UNITED STATES PATENT AND TRADEMARK OFFICE

APPLICATION NO.	FILING DATE	FIRST NAMED INVENTOR	ATTORNEY DOCKET NO.	CONFIRMATION NO.
09/849,229	05/07/2001	Sung Rong Jo	P0239/US/SH	8060

Office Action Summary

DETAILED ACTION

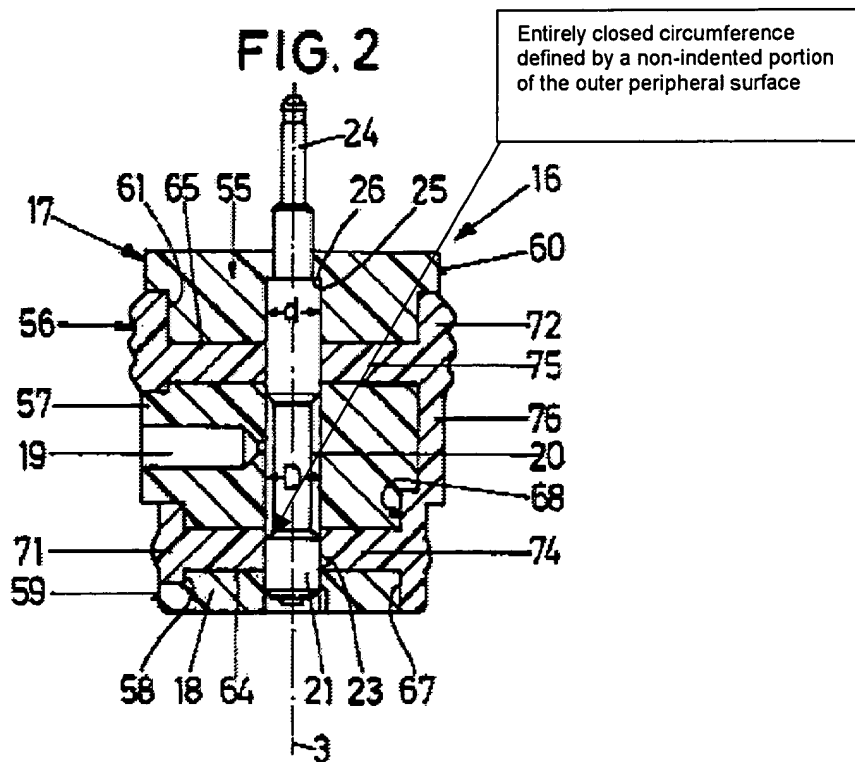
Re: claims 1, 2, 9, and 19. Weisser et al. show in figures 1 and 2 a gas

opening/closing pin which opens and closes a gas inlet and outlet 19 formed in a pipe holder 16 which seals one end portion of a cylinder 4 and moves the position of a piston 6 in the cylinder, wherein at least one indented portion 20 which opens the gas inlet and outlet is formed on the outer peripheral surface of the central portion of the gas opening/closing pin and an integrally formed stepped diameter reducing portion shown in the area of d, 24, and 26 formed at an upper end of the opening/closing pin.

Re: claims 4, 6, 15. Weisser et al. show in figure 2 the limitation wherein the diameter reducing portion is tapered as shown in the area above the lead line associated with element number 24.

Re: claims 20 and 21. Weisser et al. show in the labeled copy of figure 2 on the following page the limitation wherein the at least one indented portion has an entirely closed circumference defined by a non-indented portion of the outer peripheral surface shown in the area of element number 21 and shows the limitation wherein the at least one indented portion is has one of an oval and a circular shape by virtue of its annular shape.

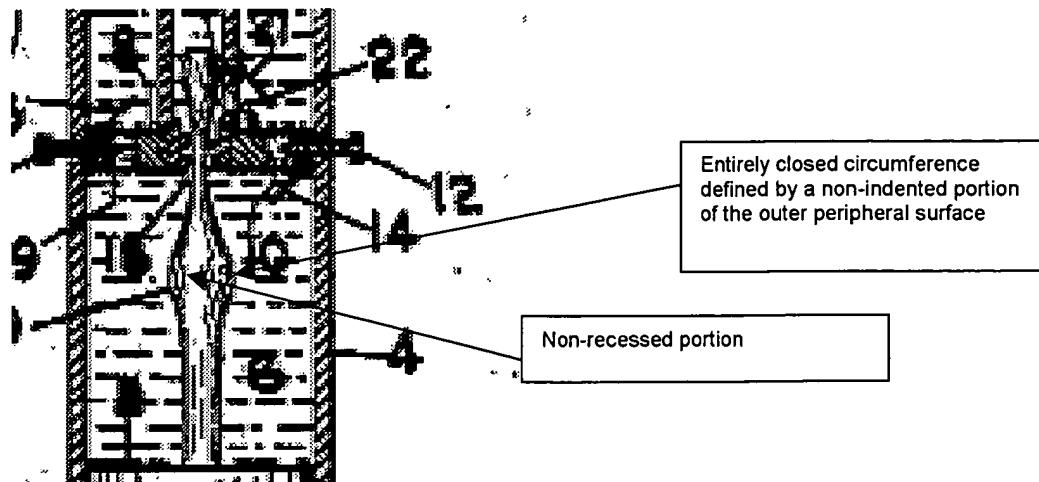
Re: claim 11. Weisser et al. teach the claimed invention. See figure 4 of Messier. Examiner maintains that Messier shows a plurality of streamlined recesses in the area of the lead line of element number 18 to the same extent as Applicant's figure 10 except the Messier reference shows additional overlapping recesses in the areas corresponding to the areas between Applicant's elements 140a.

Re: claims 22 and 23. Weisser et al., as modified, teach in figure 4 of Messier the limitation wherein the at least one streamlined recessed portion has an entirely closed circumference defined by a non-recessed portion of the outer peripheral surface as labeled in the copy of a portion of figure 4 of Messier in the following page and wherein the at least one streamlined recessed portion has one of an oval and a circular shape by virtue of its annular shape.
